July 6, 2017

Re: Docket No. 70-925; License No. SNM-928
Removal of Burial Area #2 Remediation from Decommissioning Plan

Exhibit 1

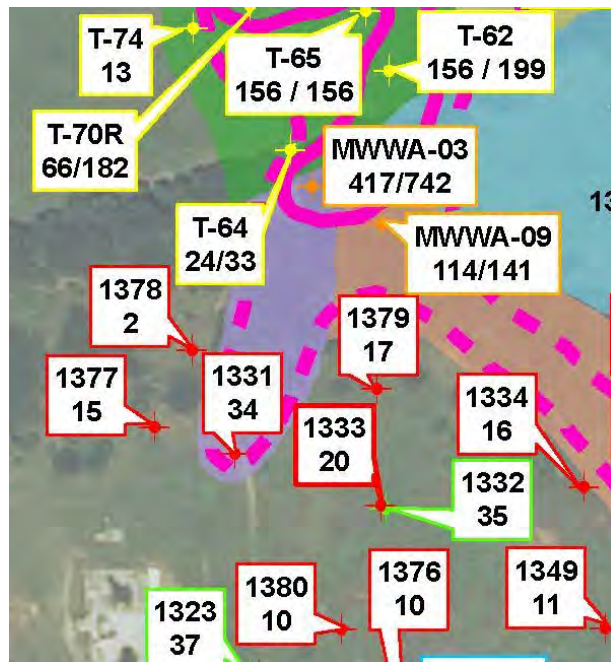
As Exhibit 1 shows, only one of the five monitor wells (Monitor Well 1331) yielded a uranium concentration exceeding the MCL in 2015. The analytical uranium concentration result for this sample, collected in April 2015, was 34 µg/L, slightly above the MCL. The extent of groundwater exceeding the uranium MCL in BA2, as depicted by the MCL iso-concentration contour shown above, was based exclusively on this MCL exceedance reported for Monitor Well 1331 (see Exhibits 1 and 2). Uranium concentrations reported for Monitor Well 1331 prior to 2015 also exceeded the MCL.

As shown in Exhibit 2, the 2015 *Facility Decommissioning Plan* included the construction and operation of a treated water injection trench (GWU-WU-02), represented by the blue line located west of Monitor Well 1331 (Exhibit 2). The blue circle near the center of the trench represents a treated water injection well installed within the trench. GWU-WU-02 was designed with a length

of approximately 177 feet and an average depth of approximately 19 feet below grade; the trench will be excavated within Sandstone A. The GWI-WU-02 trench design also provides for approximately 1,300 feet of buried piping (conveying treated water for injection) and instrumentation cable (for injection well water level monitoring) extending from the GWI-WU-02 injection well location to the Western Area Treatment Facility.

Hundreds of thousands of dollars will be required to install, operate, monitor, and abandon the GWI-WU-02 injection system for the purpose of remediating an area that now appears to comply with the DEQ criteria for unrestricted release. Therefore, we do not feel it is necessary to implement remediation in an area in which uranium concentrations appear to now comply with the DEQ criterion for uranium in groundwater.

Based on the above-described evaluation, EPM seeks your approval to remove this component of the groundwater remediation program. Please feel free to contact me at 405-642-5152 or to e-mail me at jlux@envpm.com if you have questions or desire clarification of any of this information.
